To: T10 Technical Committee  
From: Rob Elliott, HP (elliott@hp.com)  
Date: 24 December 2004  
Subject: 05-018r0 SAS-1.1 Discover process disable unused entries

sas1r07 - Serial Attached SCSI 1.1 revision 7

Figure 2 — Expander route index levels example

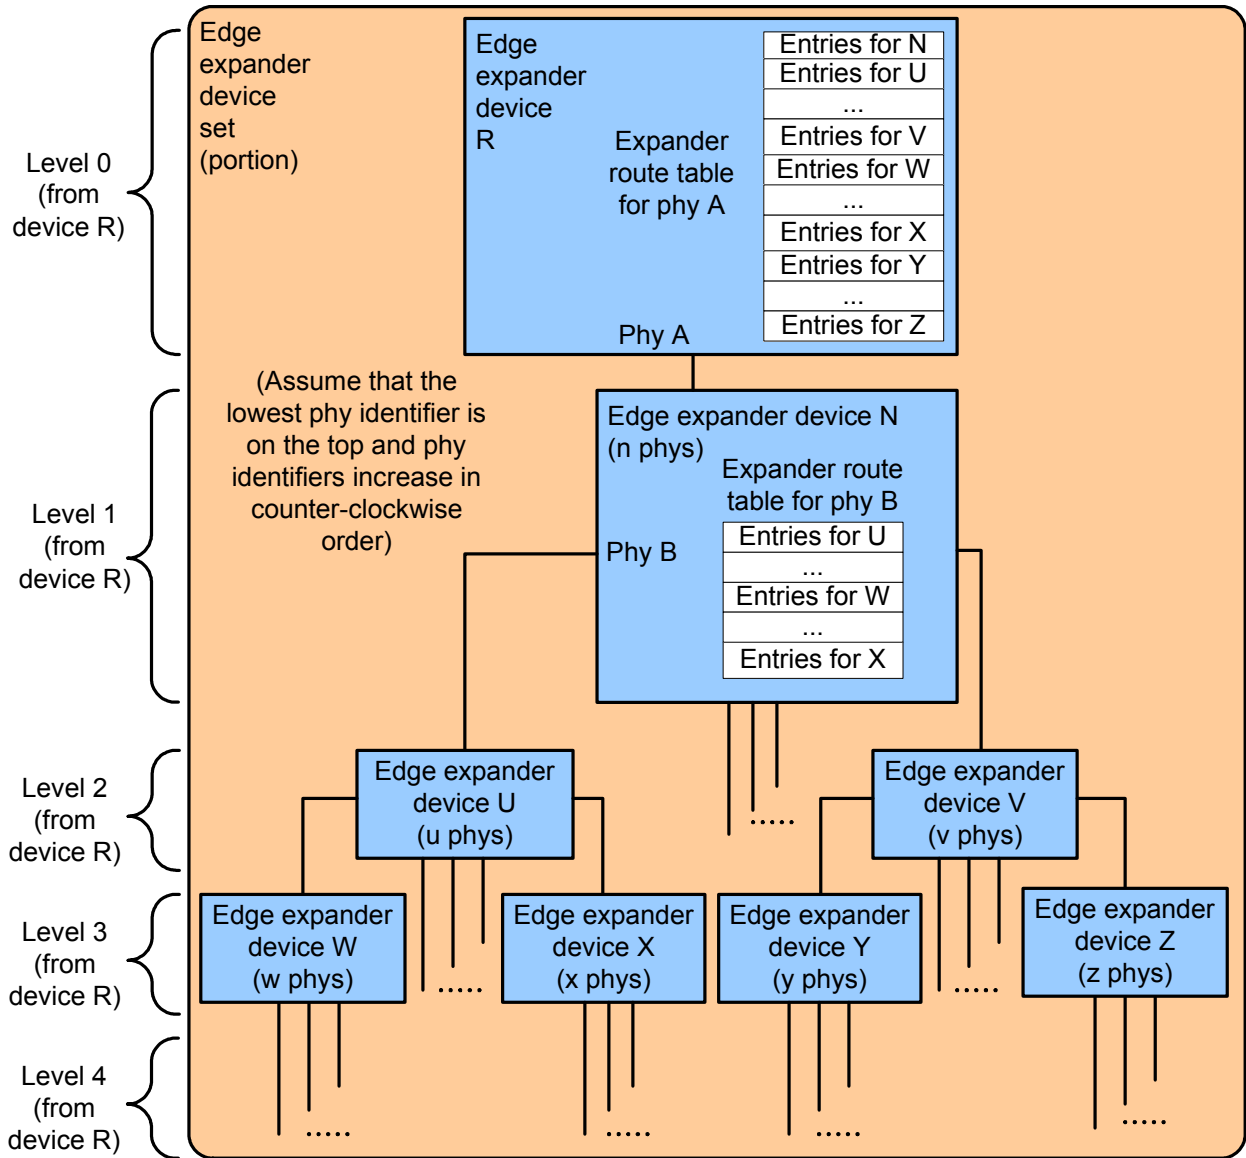
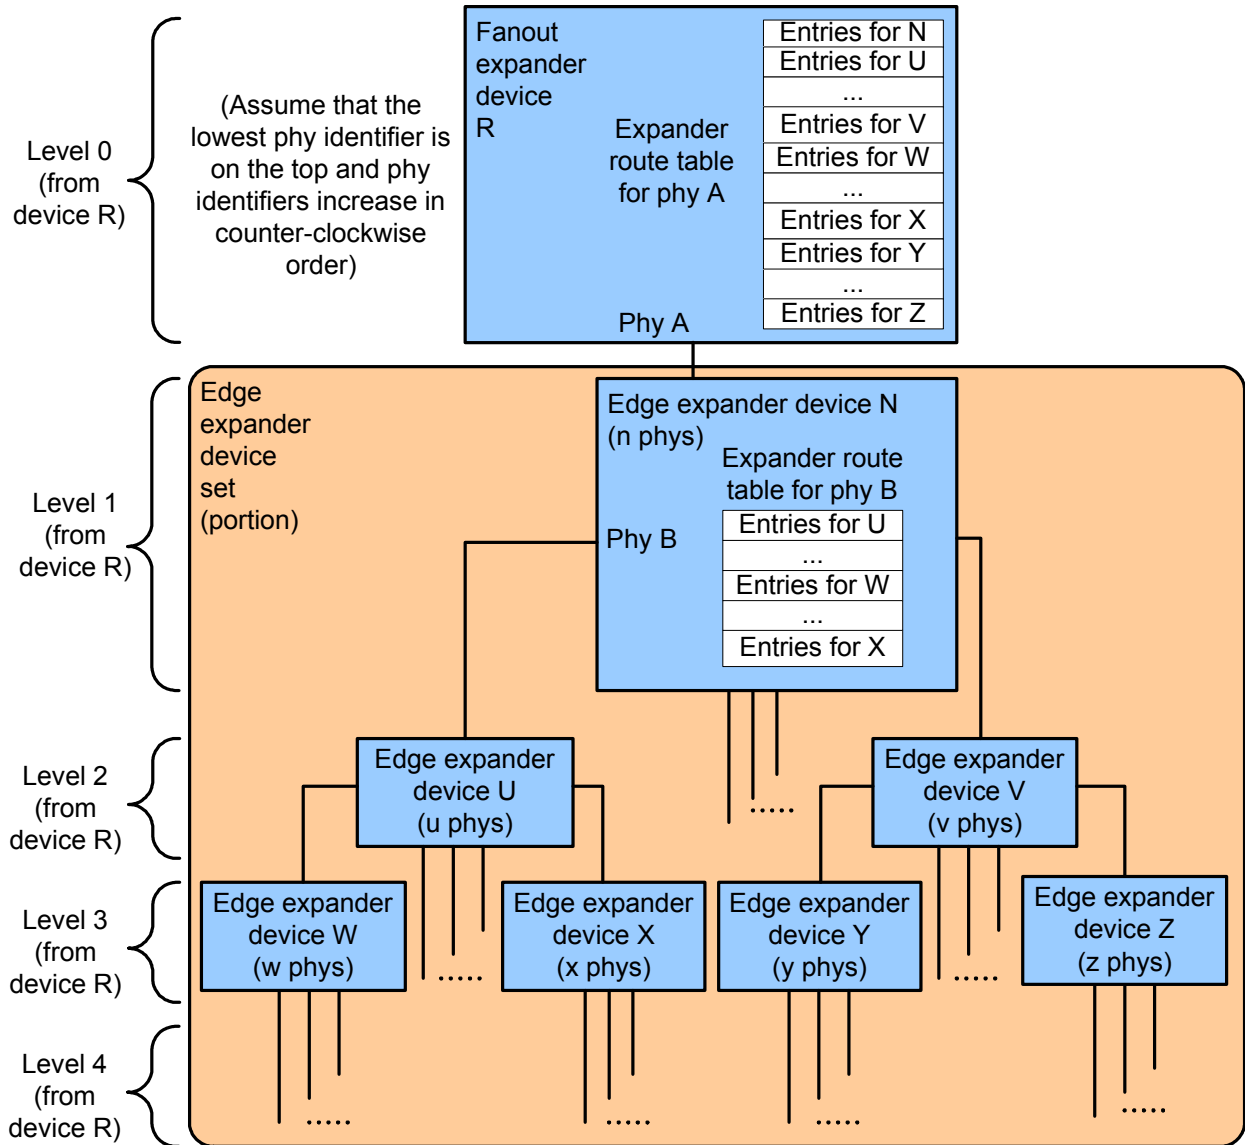
After the expander route table has been configured with entries for all levels of edge expander devices, all remaining expander route table entries, if any, shall be disabled (i.e., the ROUTED SAS ADDRESS field shall be set to 00000000 00000000h and the DISABLE EXPANDER ROUTE ENTRY bit shall be set to one).

Table 1 shows how the expander route table is configured for edge expander device R phy A in figure 2 and the fanout expander device R phy A in figure 3.

<b>Entries for additional levels</b>	
...	...
<b><u>Disabled entries</u></b>	
...	...
